# STERLING RANCH ROAD & BRIARGATE PARKWAY STORM PLANS

COUNTY OF EL PASO, STATE OF COLORADO  
STORM SEWER PLANS  
MAY 2022

# ENG-CDR22001-R3-CDs Storm.pdf Markup Summary

**DP11 PROFILE**  
**STA 10+00.00 TO 13+94.44**  
PUBLIC

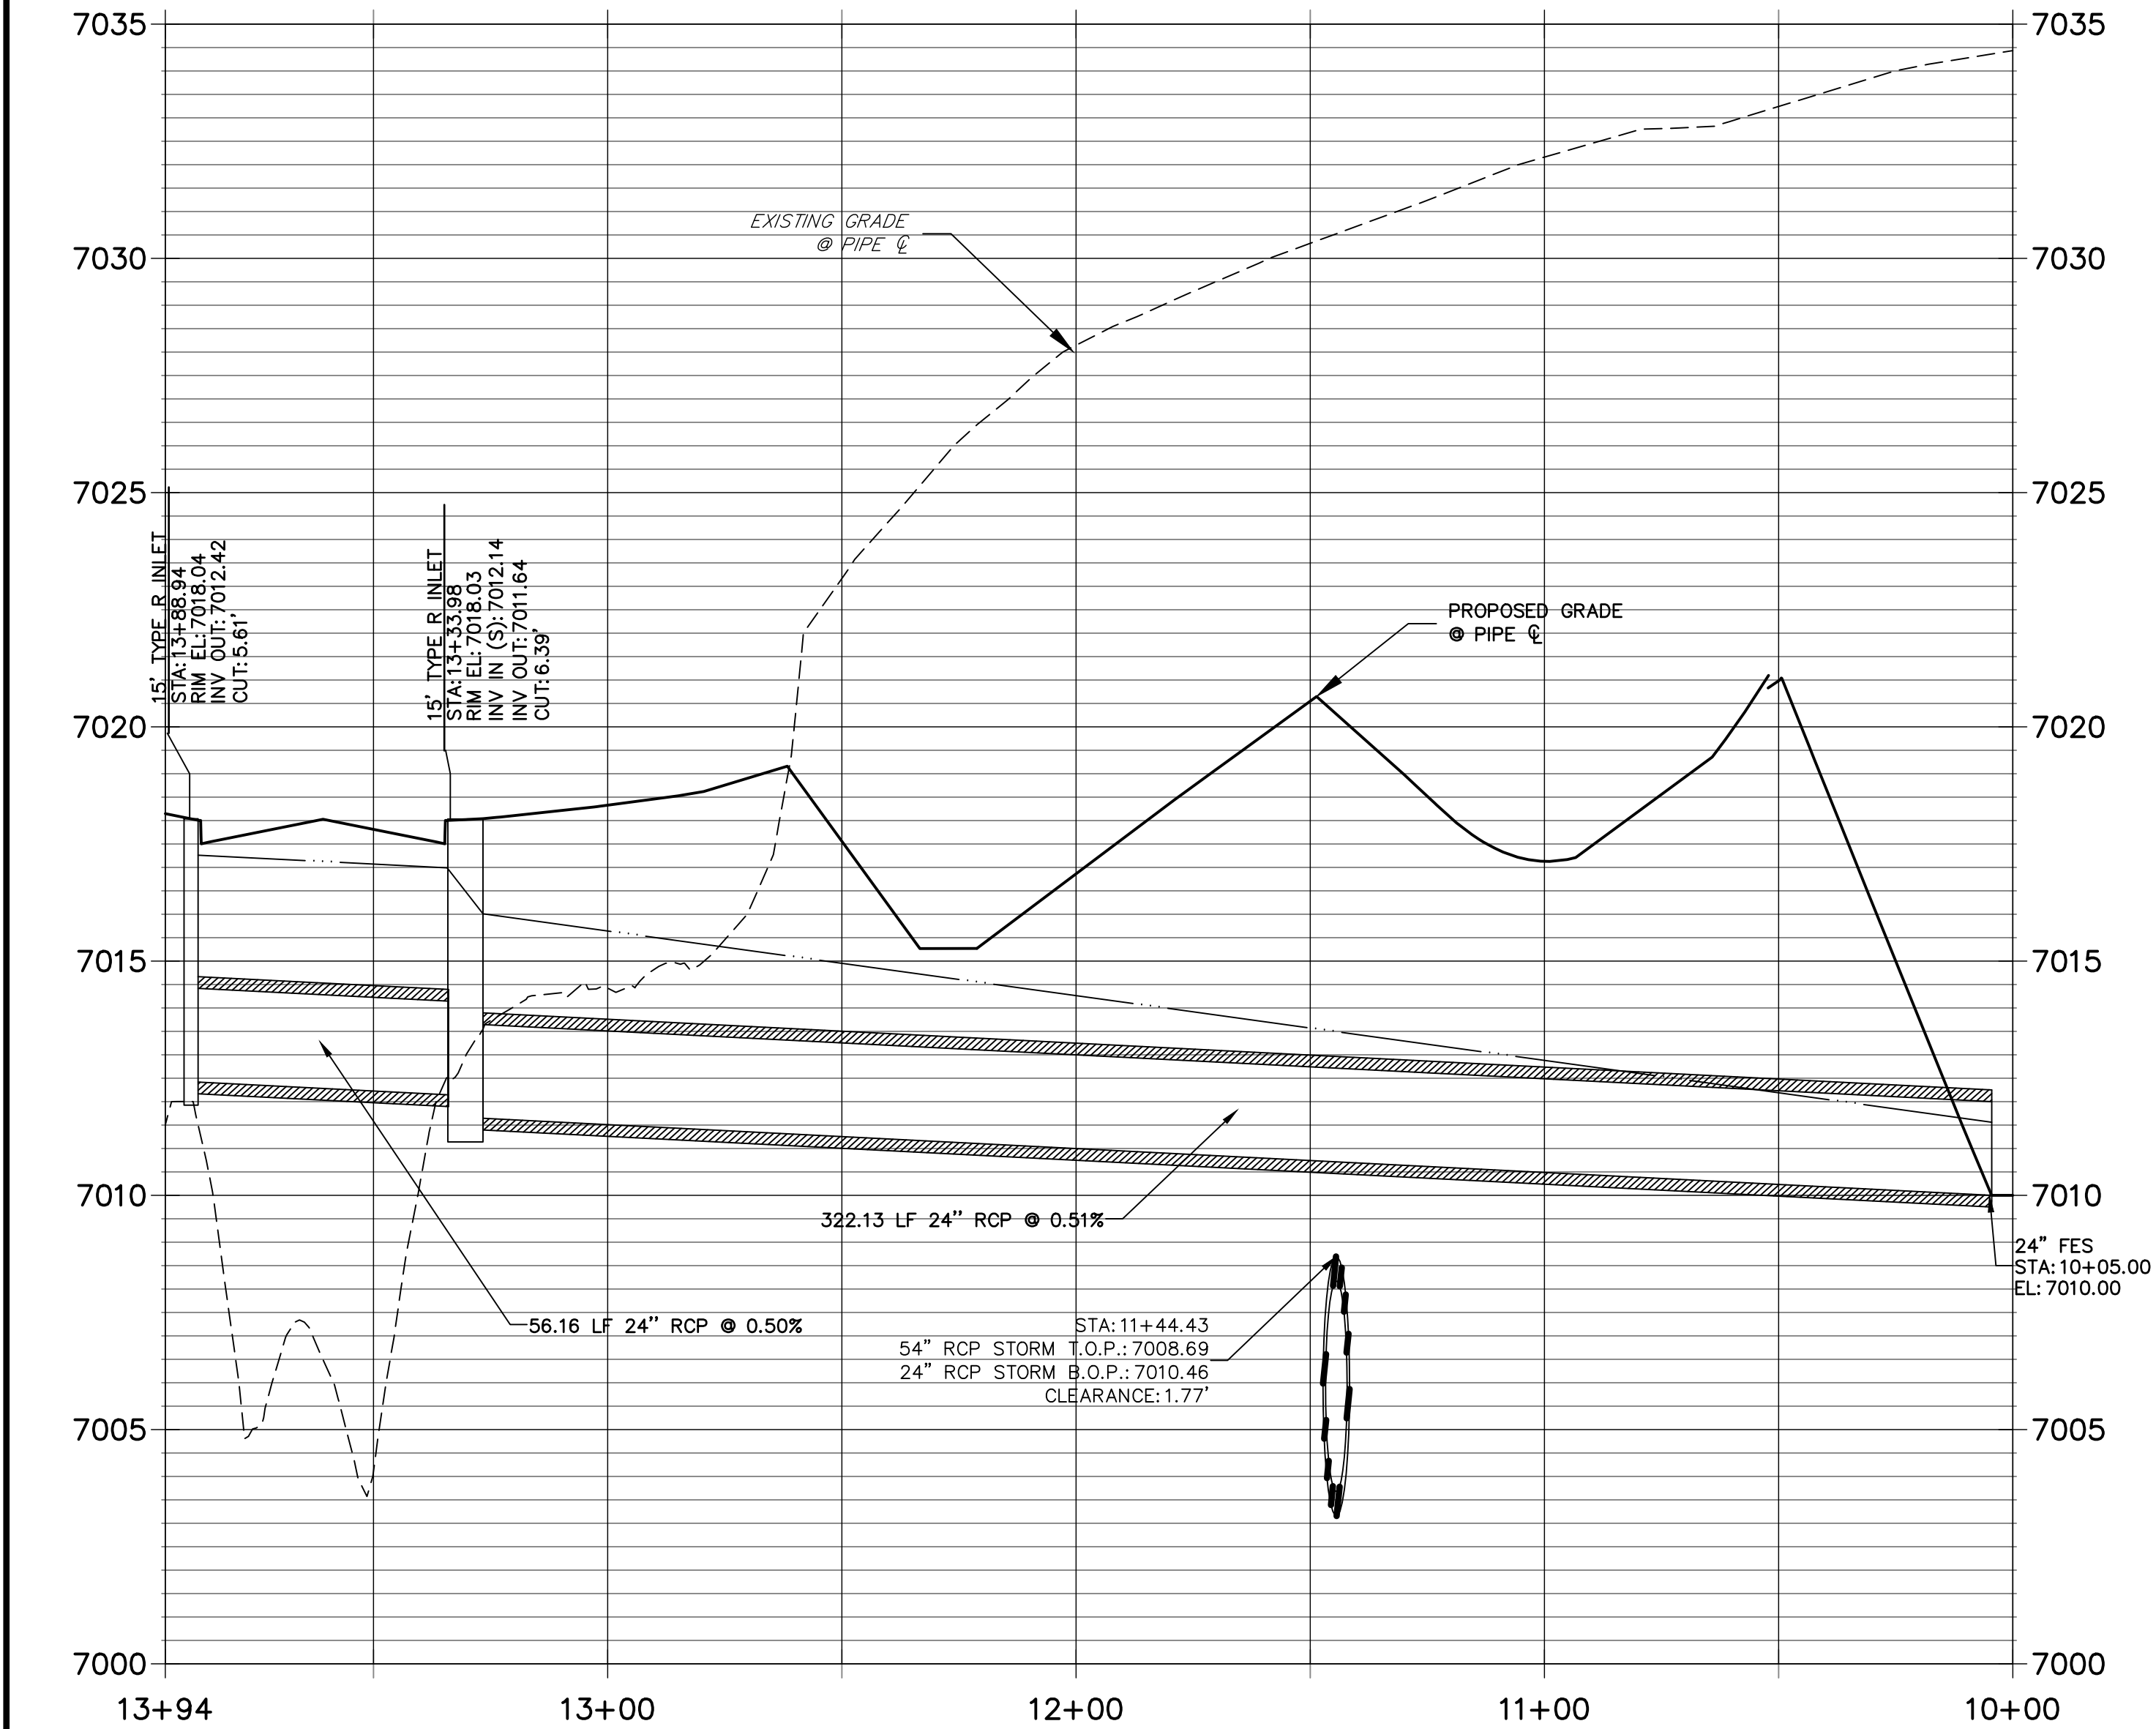
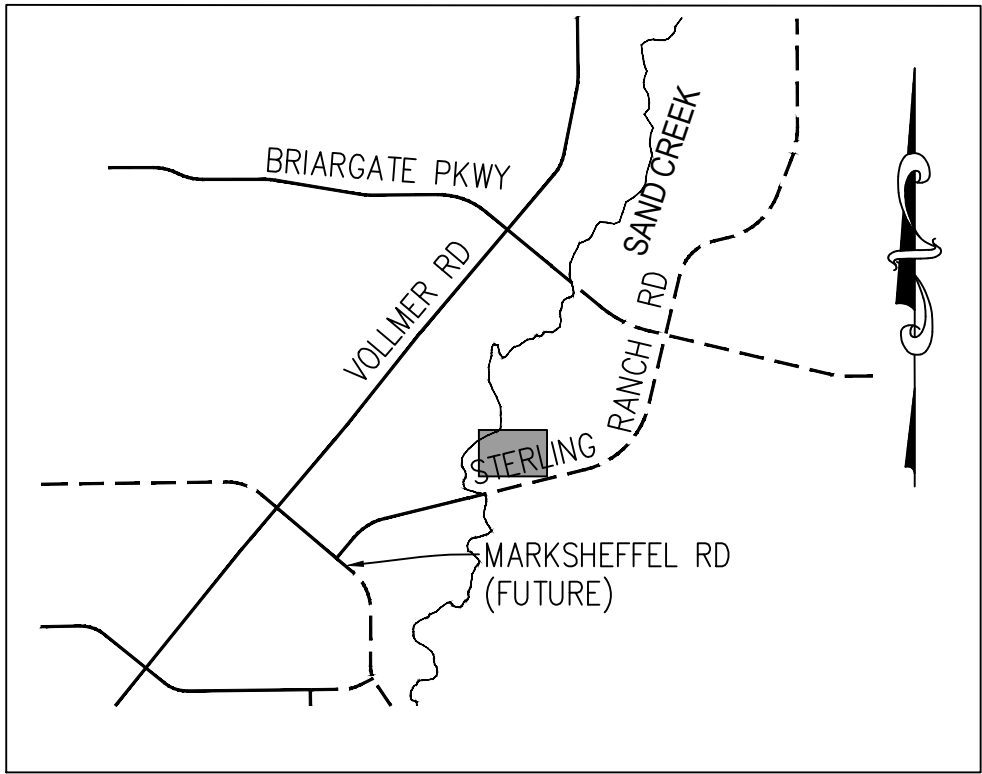
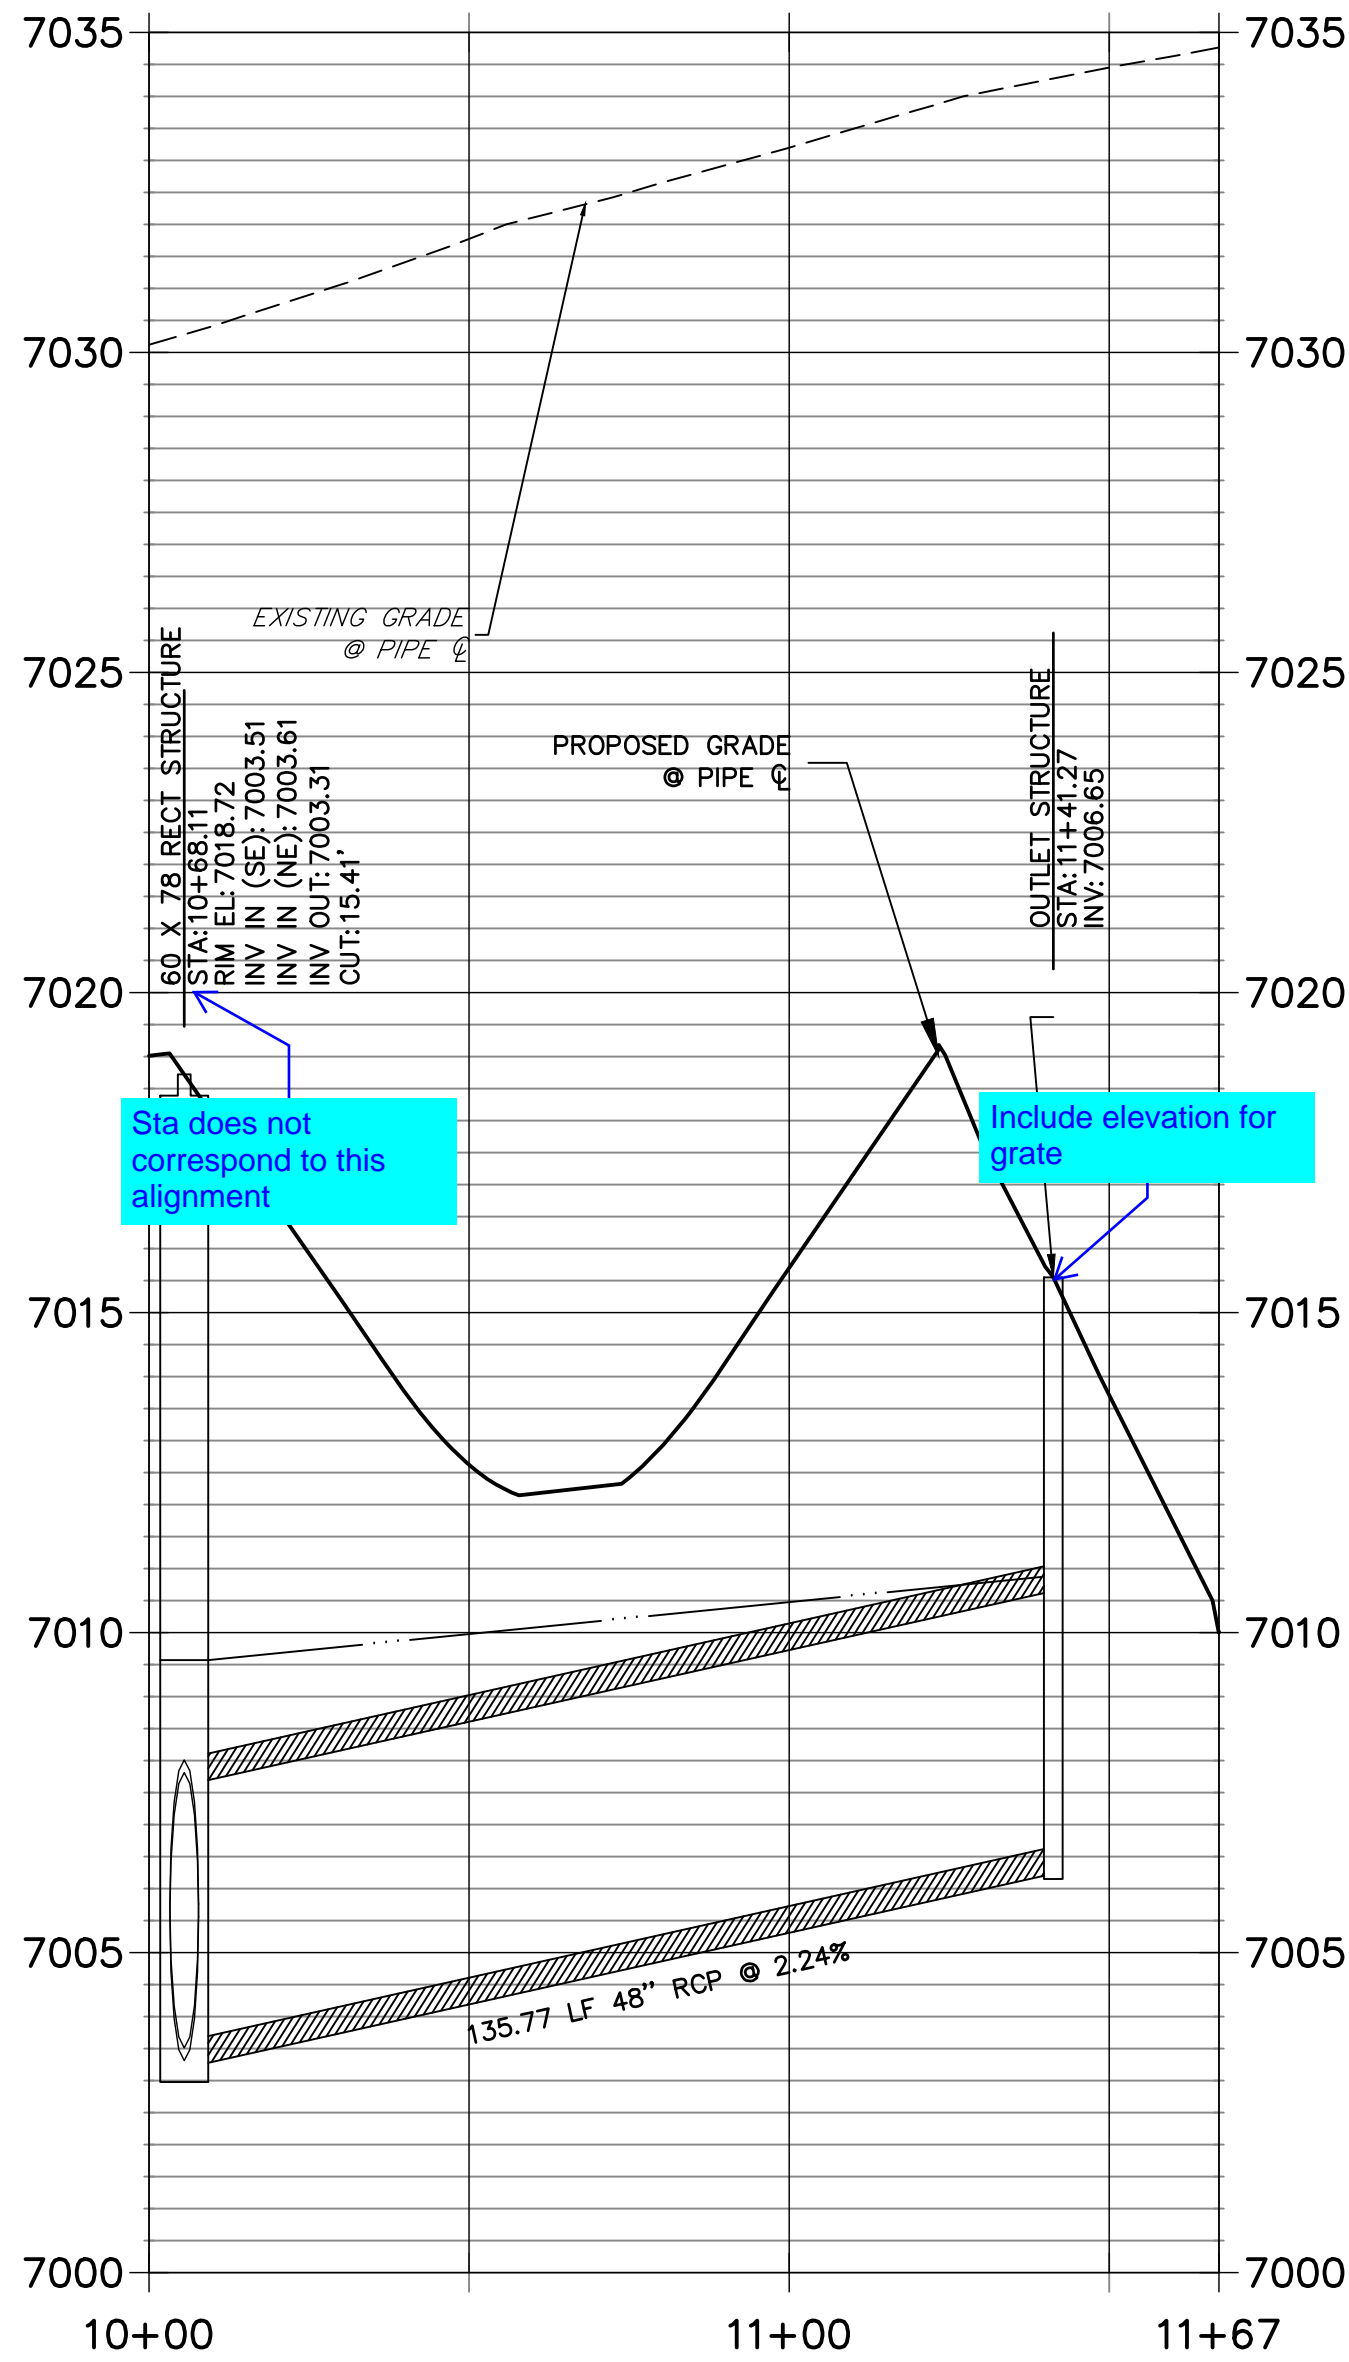
Include elevation for grate

Sta does not correspond to this alignment
